## **Engineering Assessment Report**

Mixed Use Development at Clongriffin, Dublin 13  
Strategic Housing Development Application No. 1

August 2019

**Waterman Moylan Consulting Engineers Limited**

Figure 3: Collision Plot for Road Network surrounding site

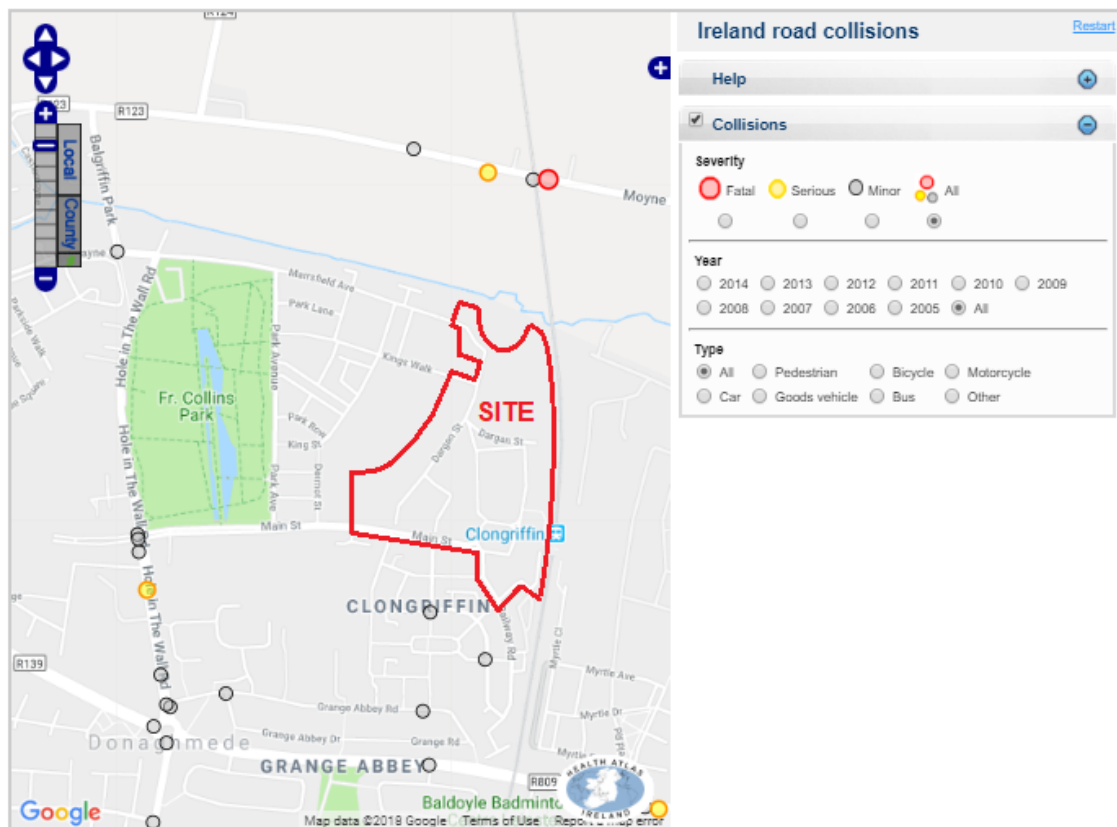
2.1.3 No information was provided on any existing collision statistics in the vicinity of the site. A review of the Road Safety Authority (RSA) online collision database indicates that there are no records of collisions on the road network within the site area between 2005-2014 inclusive. The quantum of anticipated traffic volumes for a residential development of this scale is likely to increase the overall level of risk of conflict on the surrounding road network, however the Audit Team considered that vehicular speeds are likely to be low on the network within the study area, therefore potential collision severity is likely to be low.

**Figure 5: Parked vehicles in visibility splay**

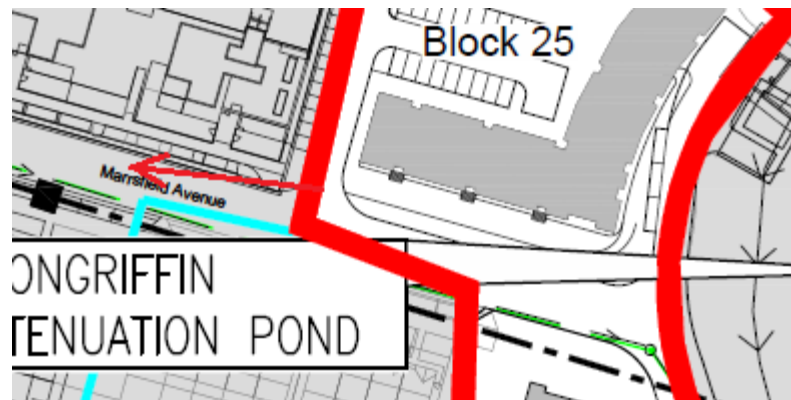
**2.1.4.4** A number of vehicles are parked within the carriageway on Marrsfield Avenue at the scheme tie-in, as shown in figure 4. Parked vehicles are obstructing the carriageway and creating obstructions in the visibility splay to the right from the new junction with the access into Block 25, as highlighted in figure 5. Parking spaces were also noted in close proximity to a number of other junctions throughout the site, where parked vehicles are likely to create obstructions and increase the risk of pulling out type incidents and right angled collisions, as well as rear shunt collisions.

2.1.4.1	Y	Y – Noted. Refer to Traffic Plan Report <sup>1</sup>		Y
2.1.4.2	Y	Y - Rounded kerb edges are proposed for all parking bays.		Y
2.1.4.3	Y	Y - Noted. Parallel parking spaces have been set back from junctions and visibility spays have been checked. Refer to revised drawings		Y

Figure 11

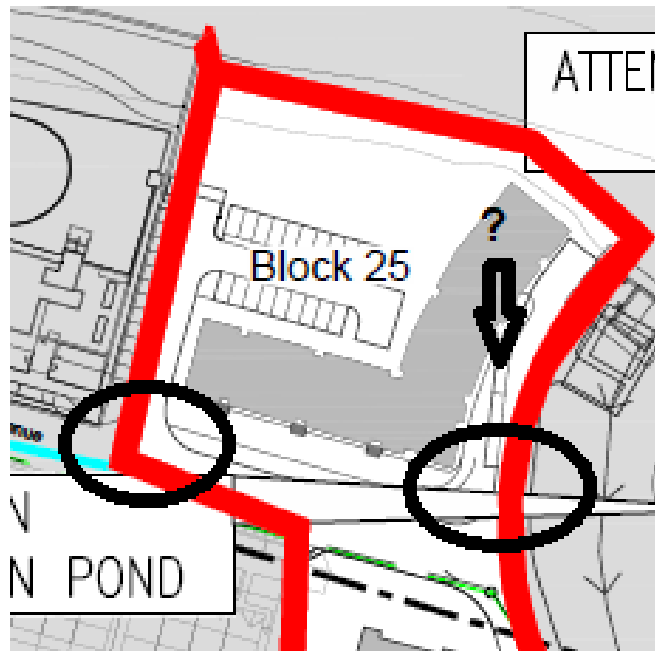
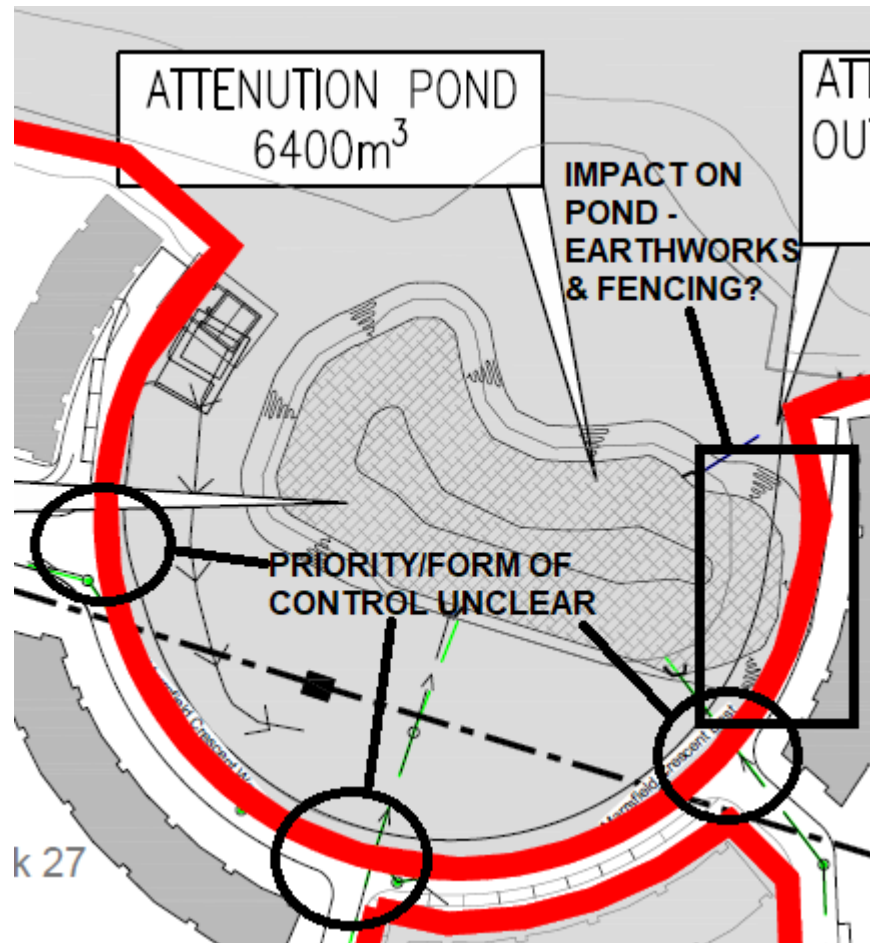
The details for the link to the east of block 25 at the north of the site are unclear, as the plan does not show kerb continuity and appears to show parallel parking spaces in the centre of the link. The priority and form of control at the two links to each side of block 25 are also unclear, as highlighted in figure 10. There is an existing substation at this location, and it is unclear if the substation will be retained, and if so, how access to and from the substation will be provided, as there is no provision for a turning circle at the northern end of the link, as shown in figure 11.

Figure 11 also shows a cul-de-sac link to the west of block 26 which will impact on the area of the existing attenuation pond, and there is no provision for earthworks and accommodation for the new pond area. There is also no provision for a turning circle or space for vehicles to turn at the northern end of this link. The priority and form of control at the other two junctions on the link surrounding the attenuation pond are also unclear, and there is no provision for fencing to protect VRUs from the water hazard and steep embankments, or for maintenance access to the pond.

The layout and form of control at all intersection points and junctions throughout the site should be clearly shown on detailed design plans, with cross section and kerb details to be provided, to include dropped kerbs to facilitate vehicular access where necessary. Kerb continuity should also be shown in Railway Lane, and surrounding Block 28 adjacent to Station Street, where no kerblines have been shown between the building line and carriageway. Suitable turning circles should be provided on all cul-de-sac links throughout the site, and provision should be made for service and maintenance vehicle access where necessary. Detailed design should include for impact on the attenuation pond at the north of the site with provision for suitable fencing, earthworks and access.

Figures 19-21

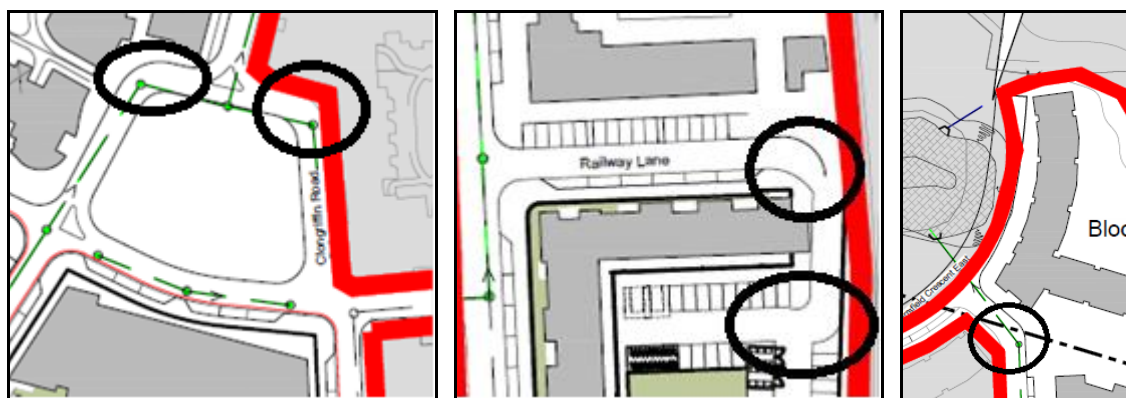
There was no swept path analysis provided to the Audit Team to demonstrate that the proposed layout will safely accommodate the swept paths of all anticipated vehicles with adequate margins of safety. The current geometry and cross section width appears restrictive on some links, particularly in the vicinity of tight radii on Lake Street and Clongriffin Rd, with examples shown in figures 19 to 22, and there has been no provision for cross section widening on any of the tight bends, which may present difficulties for safe two-way movement of larger vehicles. There are splitter islands also shown at some locations, as shown in figure 19, which will restrict some turning movements, however there were no details provided on proposed direction of circulation or permissible movements throughout the site. Elsewhere, splitter islands appeared to be located at kerblines, as shown in figure 23.

Drawing, P1130		
2.1.9	Y	Y - Refer to attached Landscape drawing		Y
2.1.10	Y	Y - Noted		Y
2.2.1	Y	Y - Noted		Y
2.2.2	Y	Y - : Refer to revised drawings and Auto Tracking drawing		Y

**Figure 33**

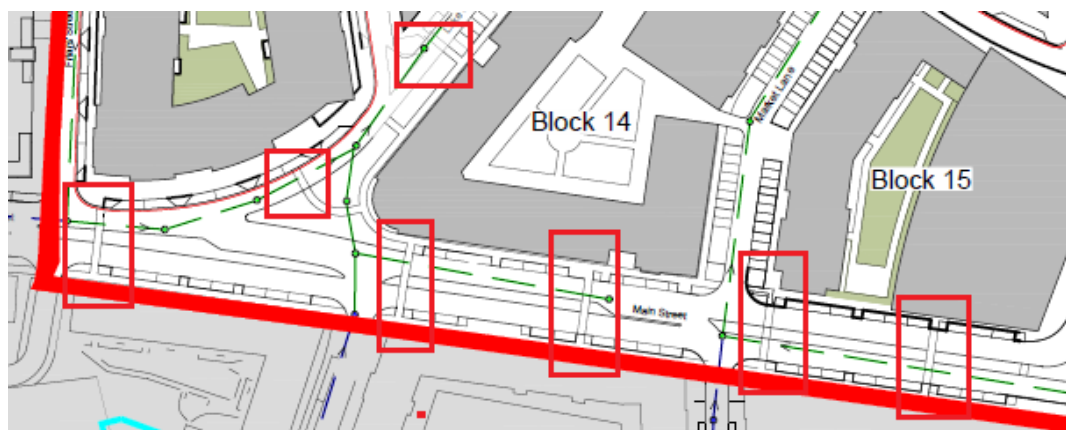
- Solid lines are shown across the carriageway at a number of locations on Main Street and Lake Street, which may represent proposed pedestrian crossing points, however there were no details provided at these locations, including form of control, configuration and width. It was noted that a number of these potential crossing points are located too close to adjacent junction and parking bays, where intervisibility may be reduced.

**Figure 37: Road Markings Showing Bus Access Only**

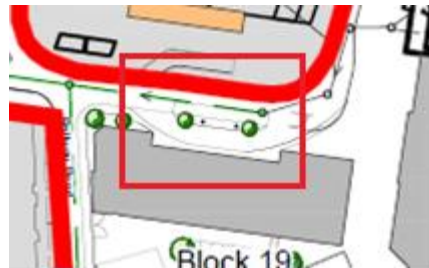
- The layout at Station Hill is misleading, with both lanes marked for buses only, but no warning signage from either direction on Station Street to prevent vehicles turning onto the link (see Photo in Figure 37 – poles are present, but there is no accompanying signage).
